**THE CITY OF ALEXANDER CITY, ALABAMA
MULTI AGENCY WASTEWATER SOLUTION – PROJECT “B”
HIGHWAY 128 SEWER FORCE MAIN
BID #24-03
(SRF PROJECT CS010329-05)**

ADDENDUM NO. 1

INLET WATTLE PROTECTION - WATTLE
SCALE: N.T.S.

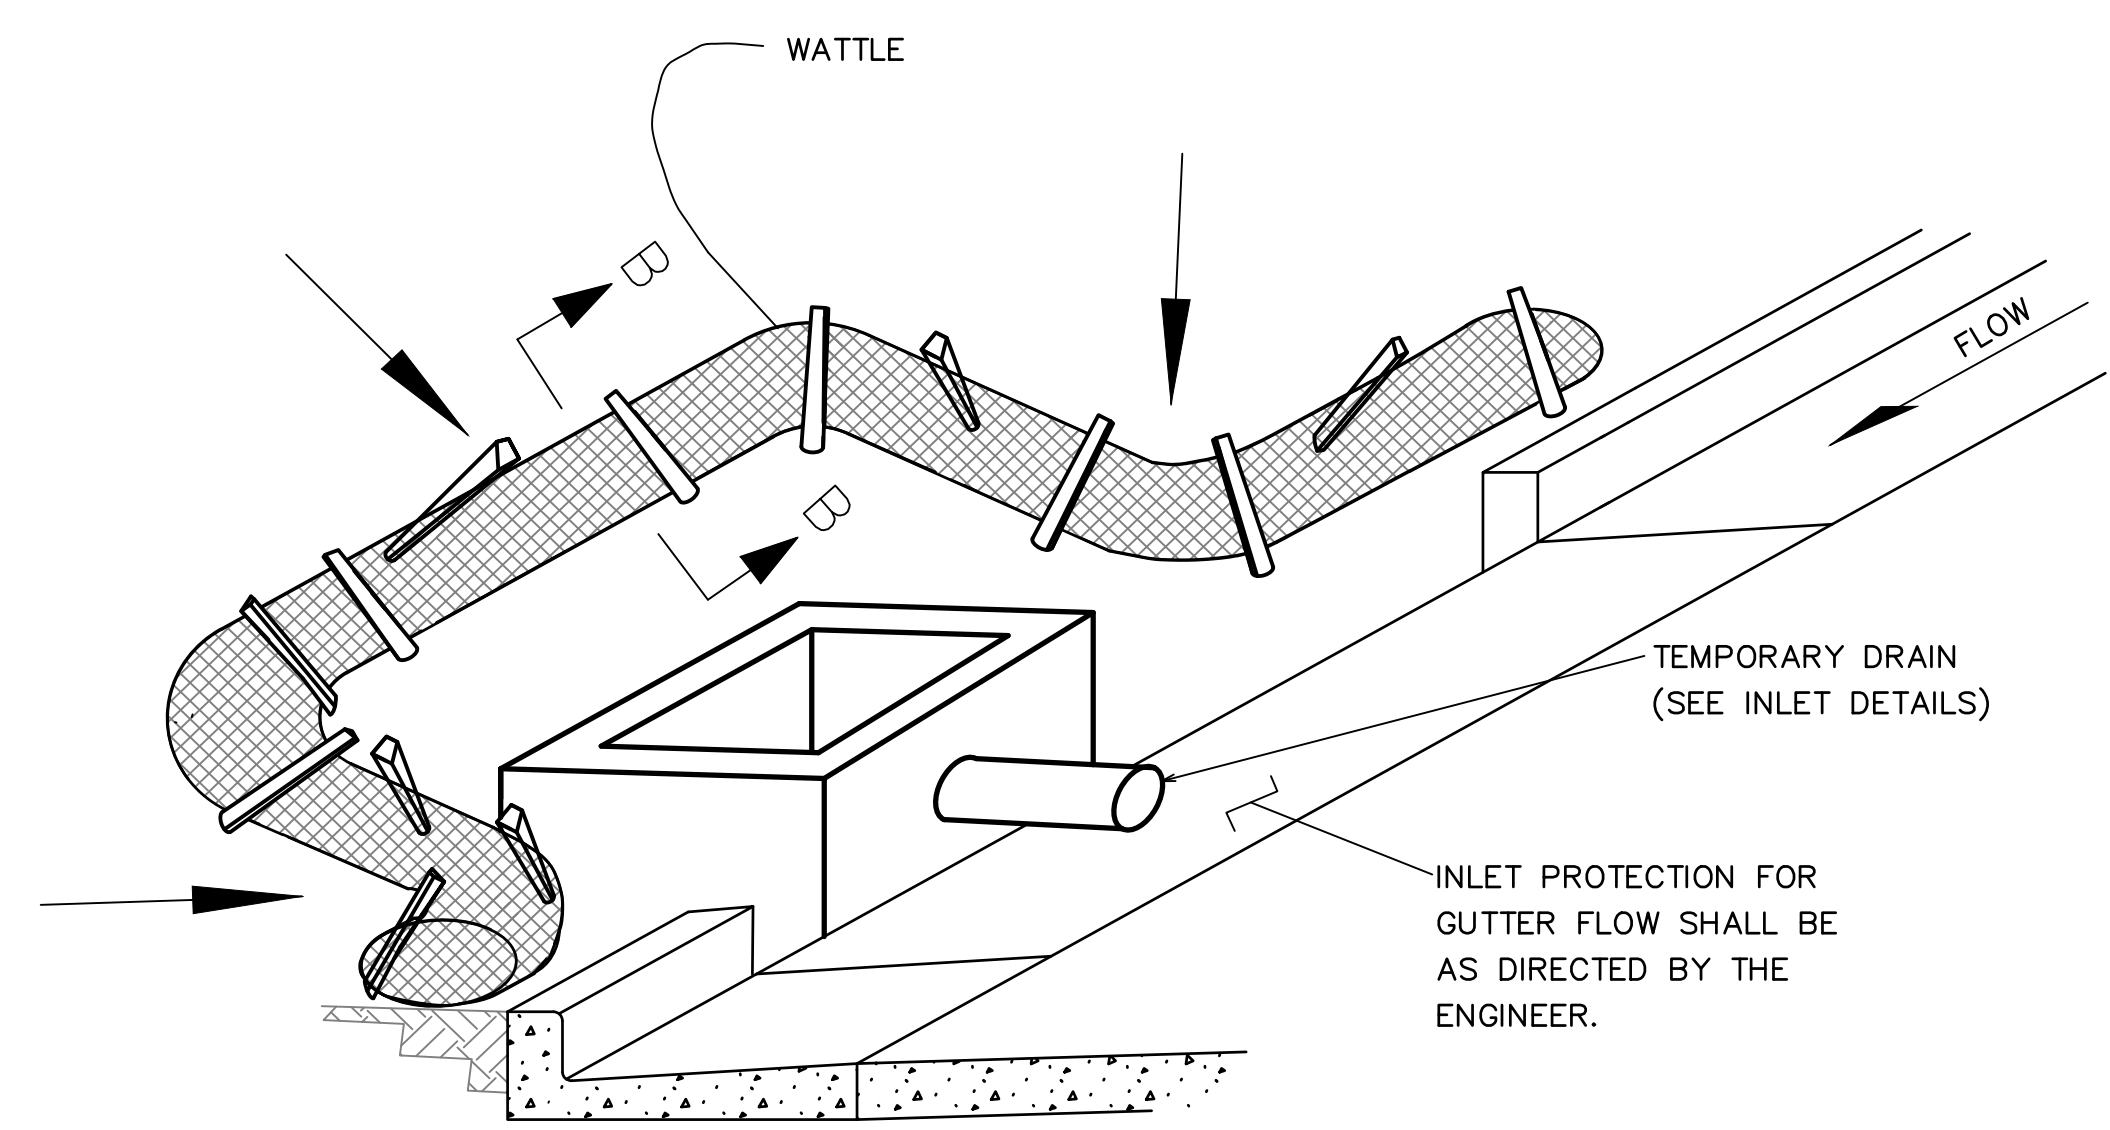
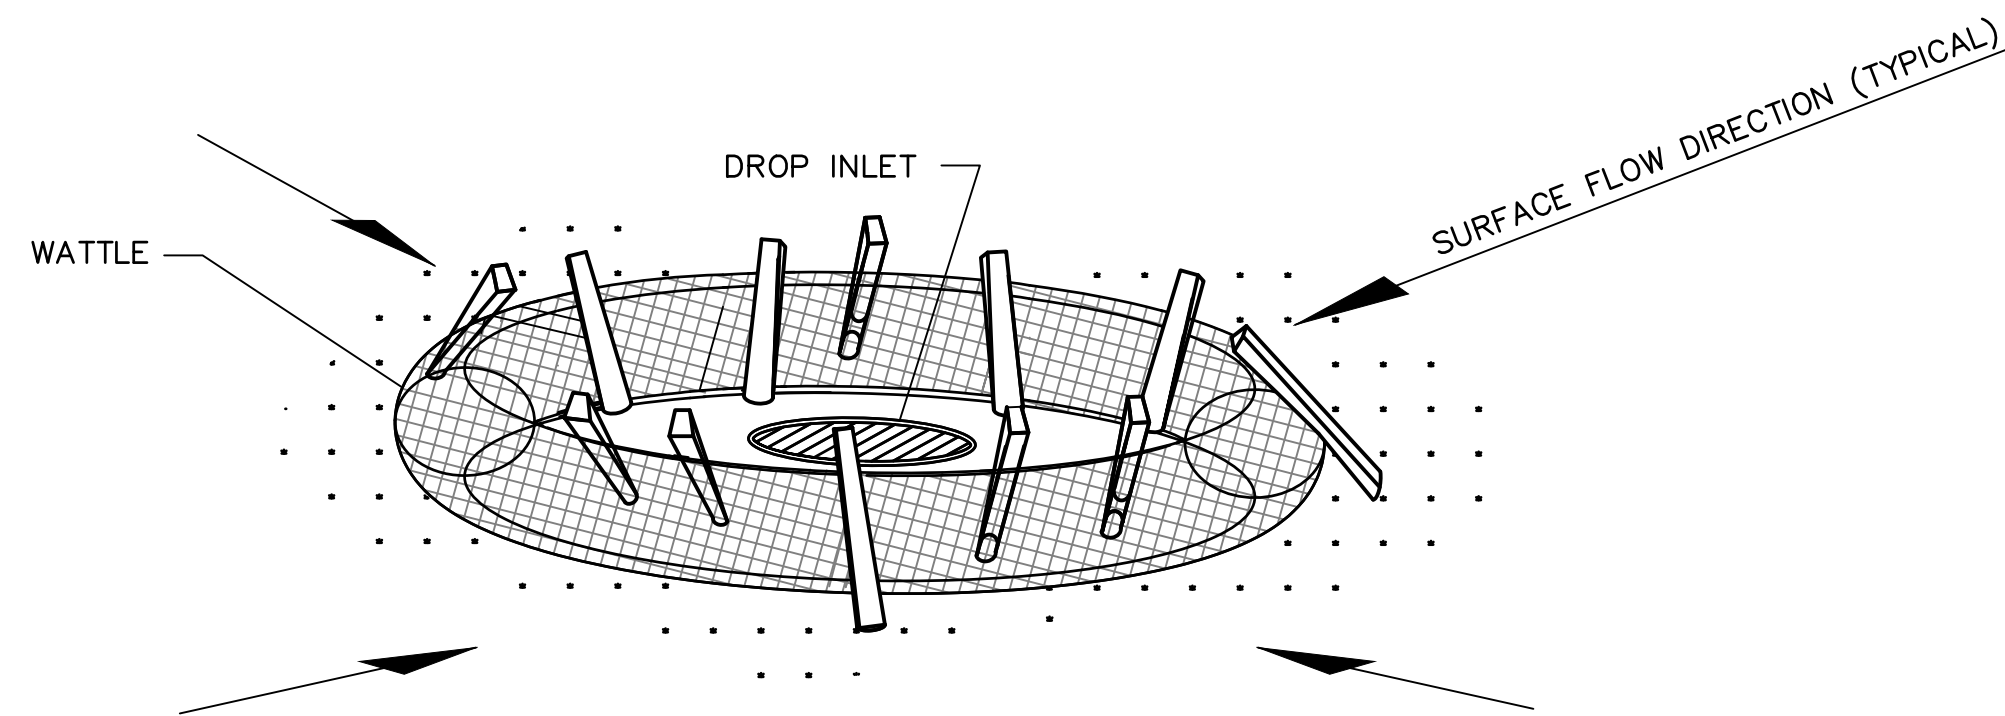
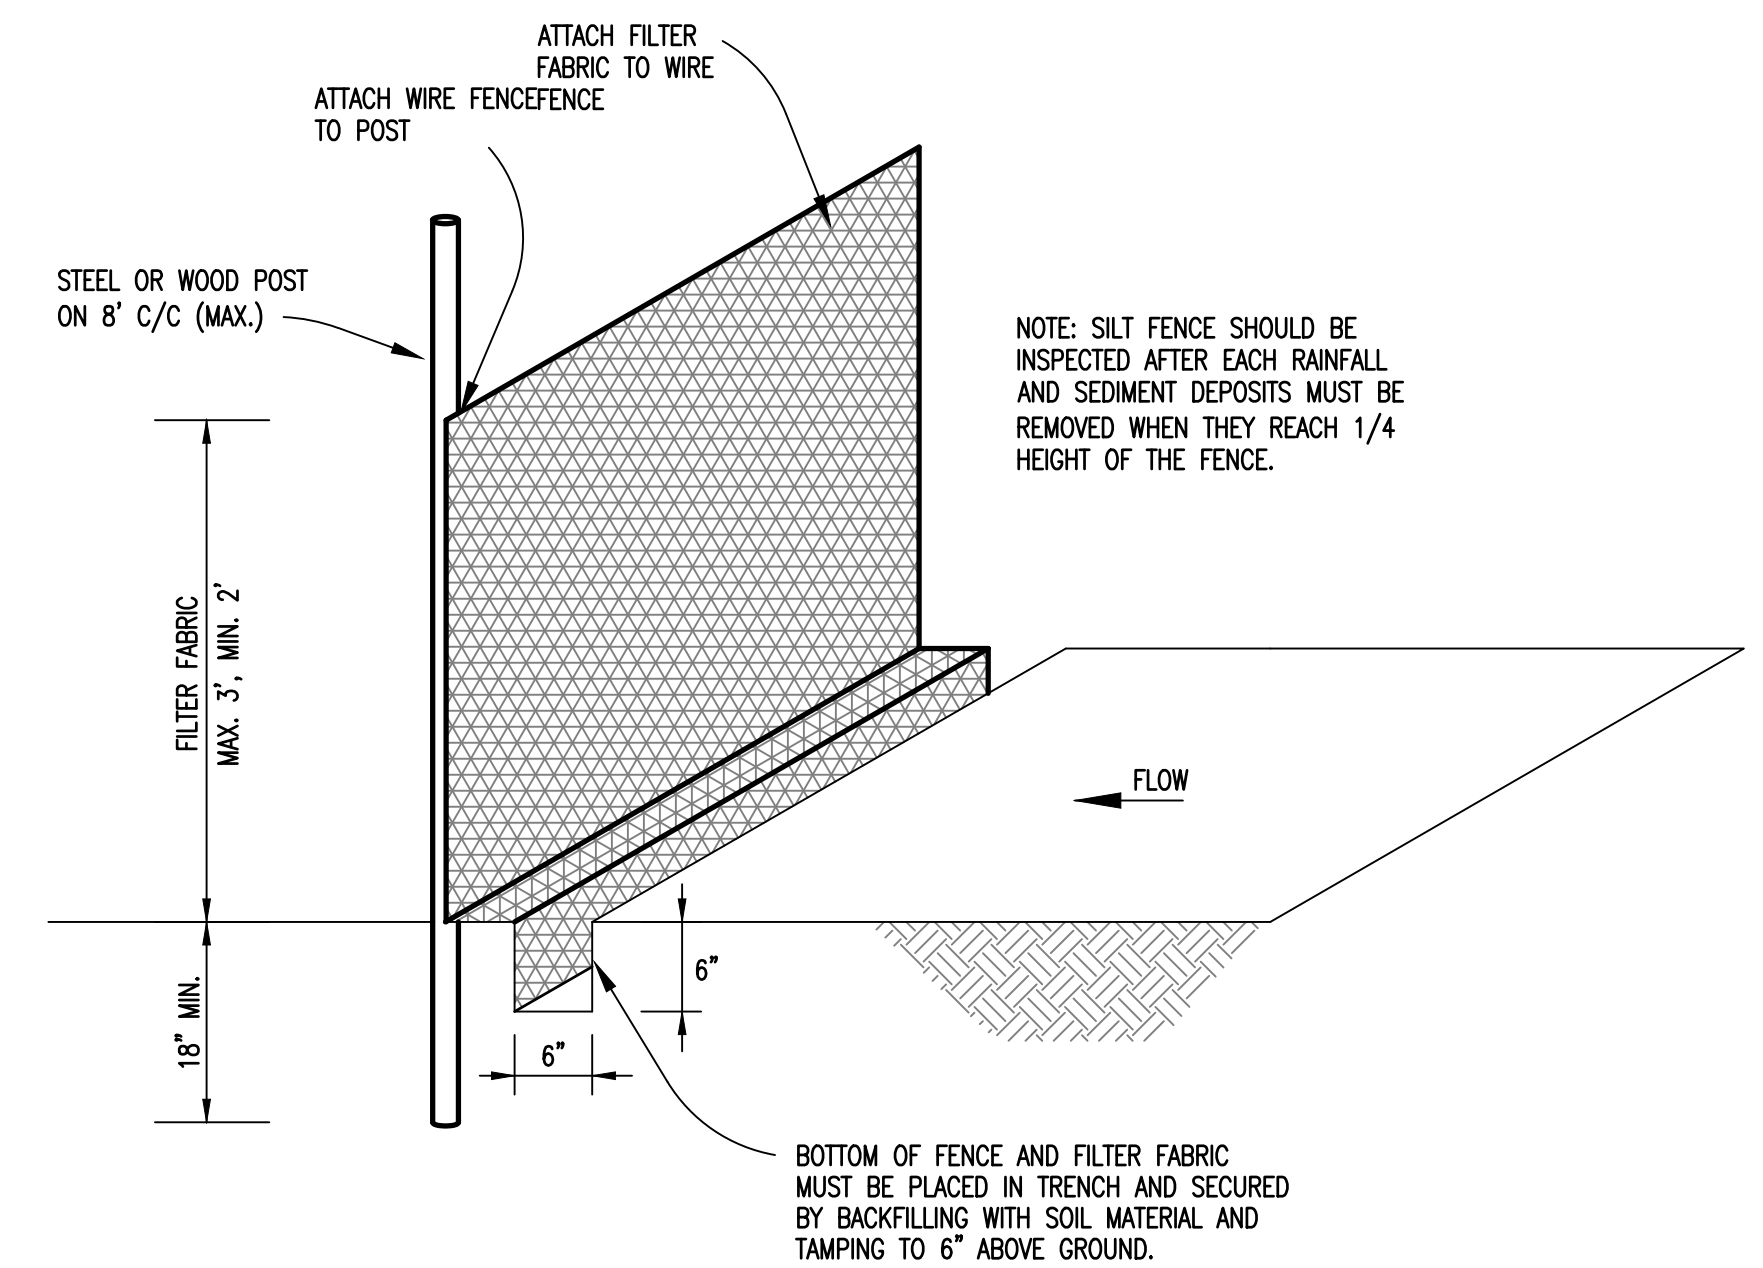
Sheet D7 Per the 2022 revision of the *Field Guide for Erosion and Sediment Control on Construction Sites in Alabama* the Hay Bale details have been replaced with Wattle Inlet Protection device details.
